**FINDINGS AND RECOMMENDATION
OFFICE OF PLANNING AND ZONING
ANNE ARUNDEL COUNTY, MARYLAND**

CASE NUMBER: 2025-0249-V

REQUEST

The applicants are requesting a variance to allow an accessory structure (pavilion) with less setbacks and buffer than required on property located at 1208 Southbreeze Lane in Annapolis.

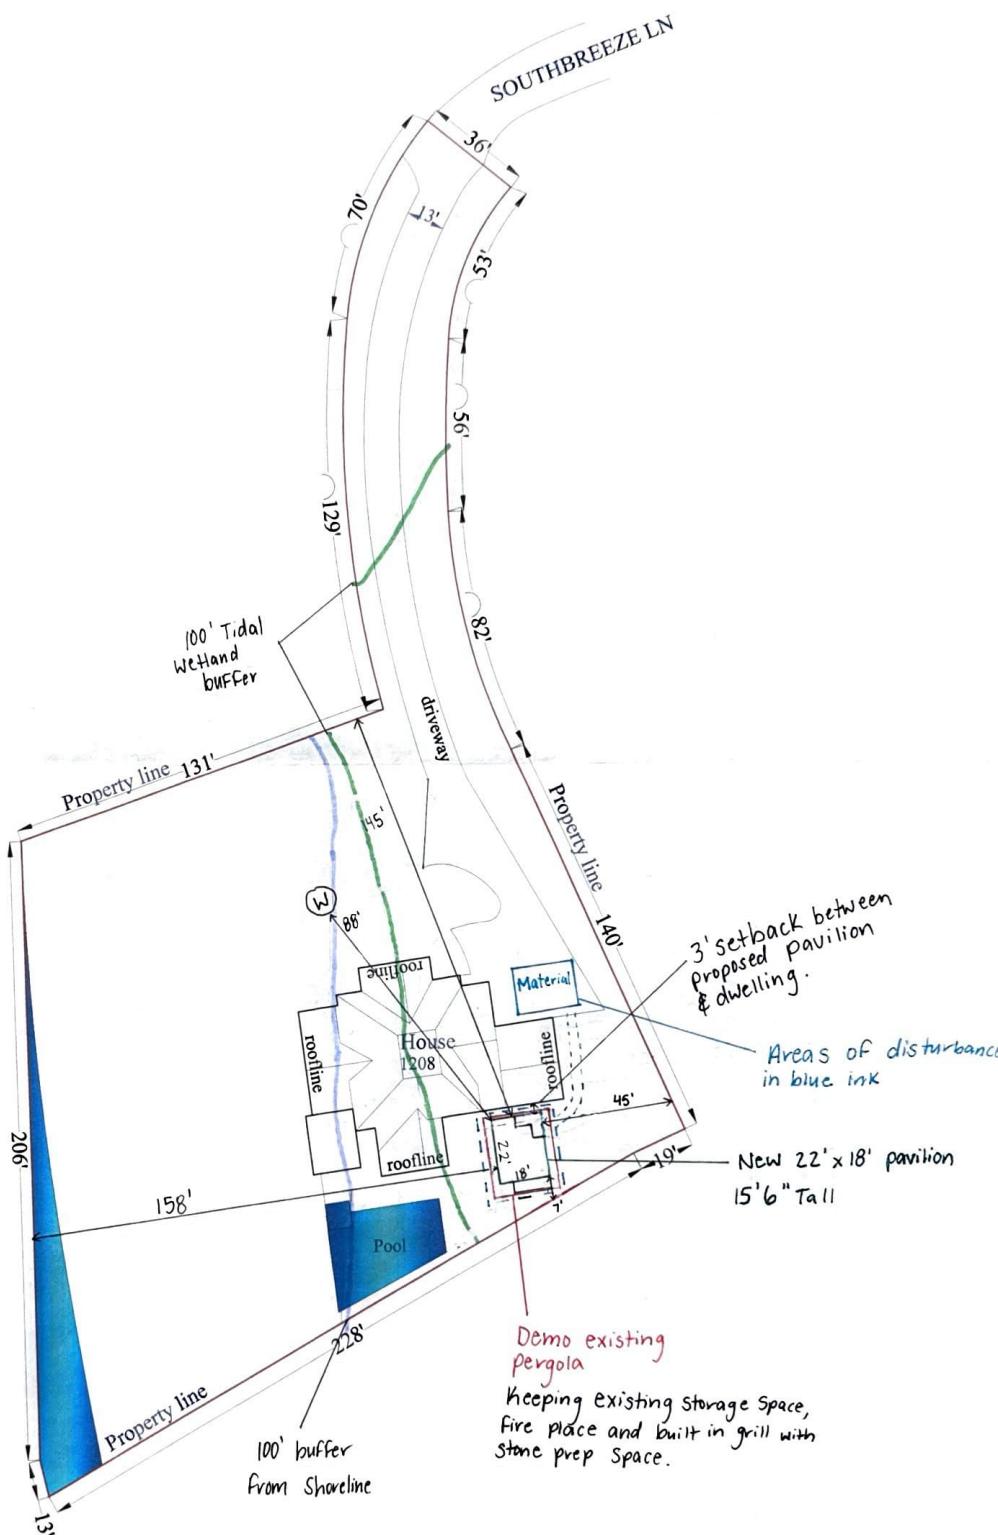
While the proposed pavilion also needs setback relief, its smaller size shifts it farther from the side lot line than the existing pergola. Because the applicants are proposing to build a smaller structure within the footprint of the existing structure, the granting of the variance will not alter the essential character of the neighborhood or district in which the lot is located, will not substantially impair the appropriate use or development of adjacent property, nor will it be detrimental to the public welfare.

- approval of variances to § 17-8-301 and § 18-13-104 to disturb the buffer; and,
- approval of a variance to § 18-4-501 to allow an accessory structure with less setbacks than required.

(Pergola) Roof Frame Plan $\frac{1}{4}'' = 1'0''$

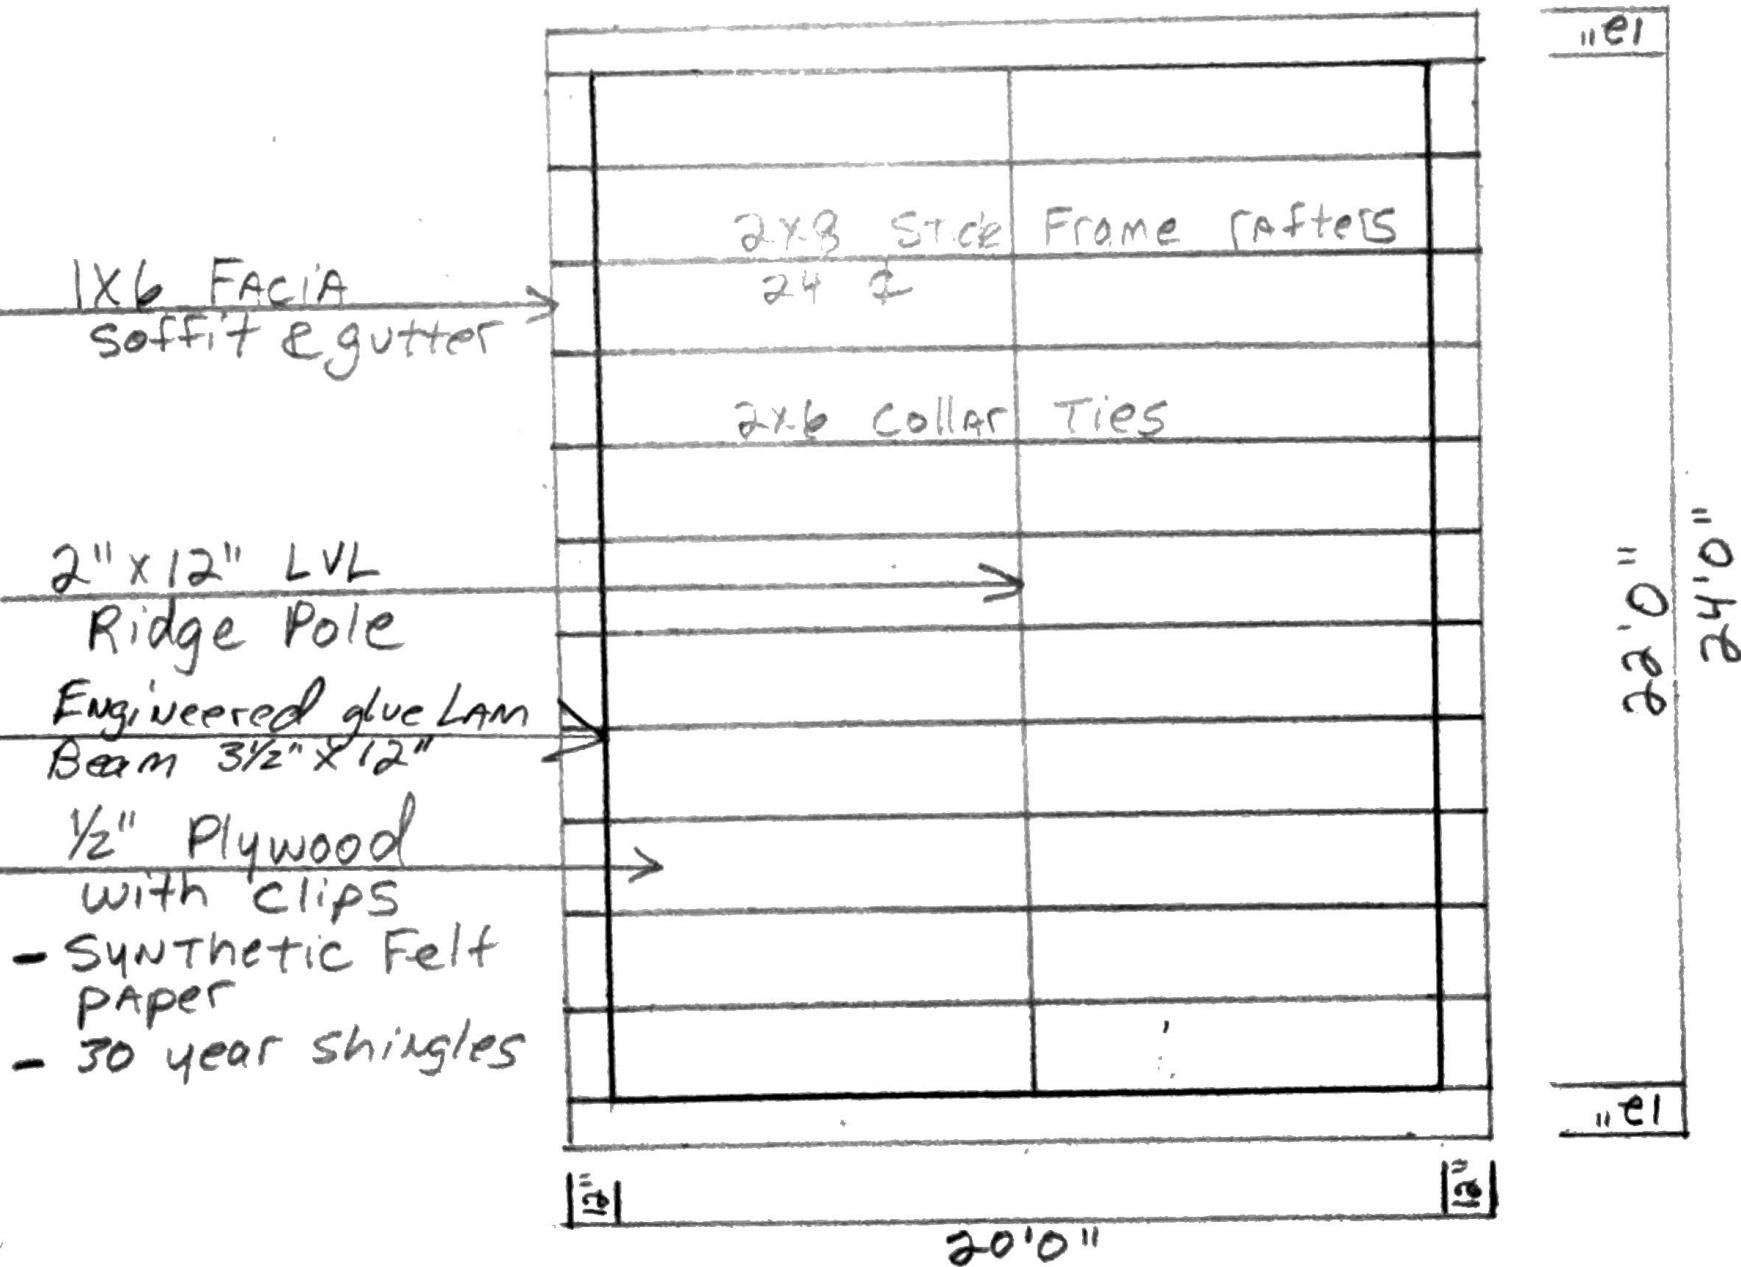
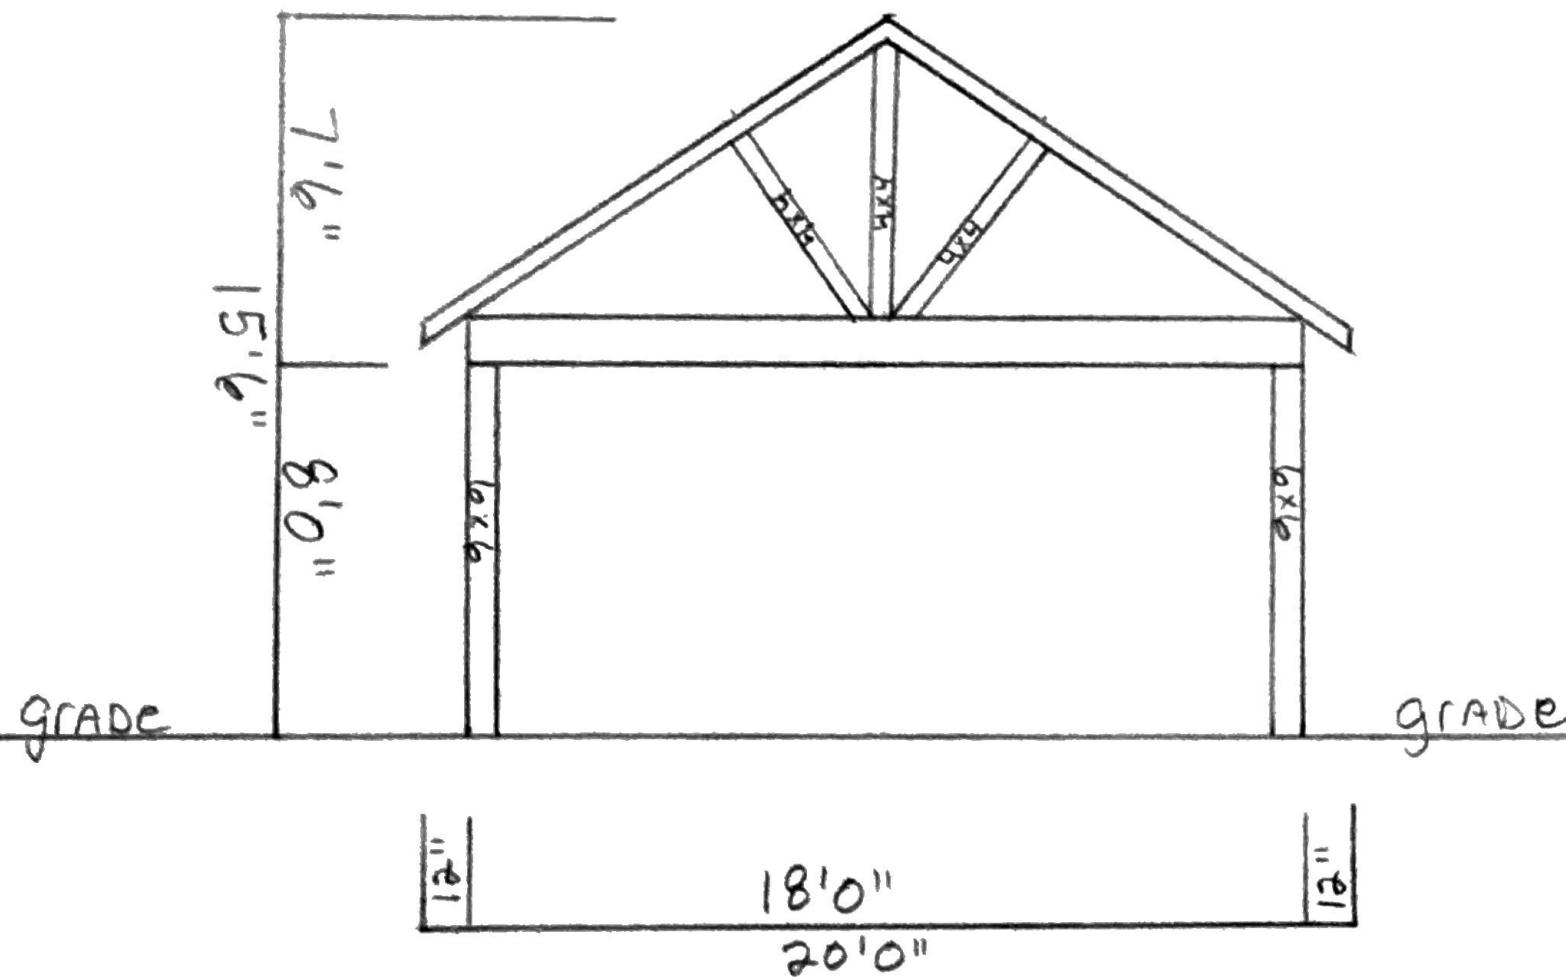
No objection to the reconstruction of the existing pergola within the existing improved recreation space. Mitigation will be addressed with the permit application.
